19/3097M Objection – Henbury Parish Council

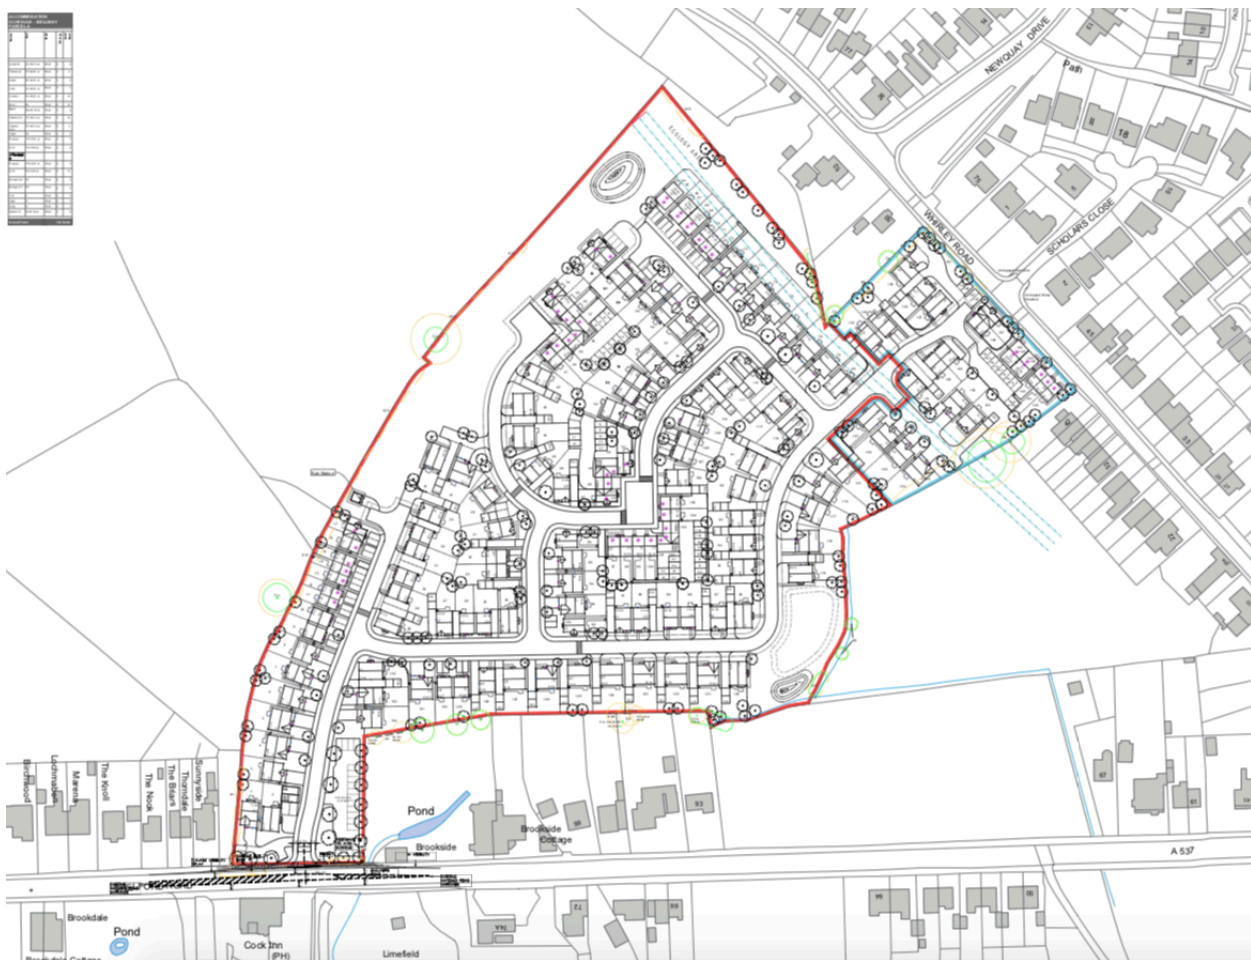
On the site plan below we can clearly see that the proposed density of houses on the site is far higher than that in the surrounding area. Therefore, the plans are out of keeping with the surrounding area.
